Fact Sheet

For Final Minor Modification Permitting Action Under 45CSR30 and Title V of the Clean Air Act

Permit Number: **R30-10700001-2016**
Applications Received: **July 2, 2018 and September 13, 2018**
Plant Identification Number: **107-00001**
Permittee: **E. I. du Pont de Nemours and Company**
Facility Name: **Washington Works**
Manufacturing Unit: **Nylon Resins Production (Part 5 of 14)**
Mailing Address: **P. O. Box 2800, Washington, WV 26181-2800**

Permit Action Number: MM03 and MM04 Revised: February 12, 2019

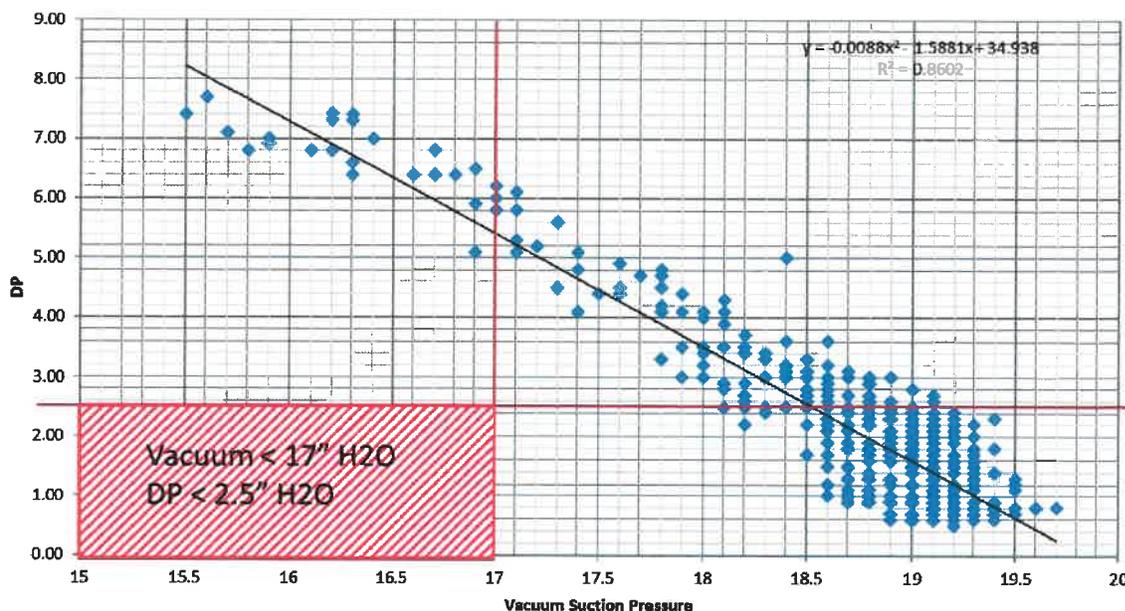
When the system was first described for permitting, all pickup points were open at all times and the pressure drop across the demister filter media was always greater than 2.5 w.c. if the media was properly positioned in the device. More recently the individual air pickup points were equipped with shut off doors to allow the air flow to be stopped for periods between active polymer drops. This was necessary in order to prevent formation of black specks due to overheating of polymer between drops. When several or most of the air pickup points are blocked, the pressure drop across the filter media often drops below 2.5 w.c. because the pressure drop (DP) is proportional to the reduced air flow.

For the reduced flow situation, proper operation of the demister is assured if the pressure at the suction port of the device is more negative than -17" w.c. The following data (plotted) was observed for normal operation over a three-week period with many combinations of open and closed pickup points. Any data points that show a pressure drop (DP) below 2.5" w.c. have suction-side values well above -17" w.c.

If the filter media was not placed correctly, then the pressure drop (DP) readings would be low, but the suction pressure readings would be well above -17" w.c.

If the filter media was not placed correctly, then the pressure drop (DP) readings would be low, but the suction pressure readings would be well above -17" w.c., in the red shaded area of the plot.

The data plot shown is for data points based on 1-minute averages. DuPont requested that the compliance monitoring requirement be based on daily averages, which is consistent with the existing permit condition for a single daily reading for the demister pressure differential.

Condition 5.4.6. – The pressure drop across the demister was required to be greater than 2.5" w.c. (inches water column). This has been revised to greater than or equal to 2.5" w.c., or, if below, the daily average gauge pressure (vs. atmosphere) shall be more negative (i.e. smaller) than -17" w.c. (inches water column) before the packing shall be inspected for possible replacement or redistribution.
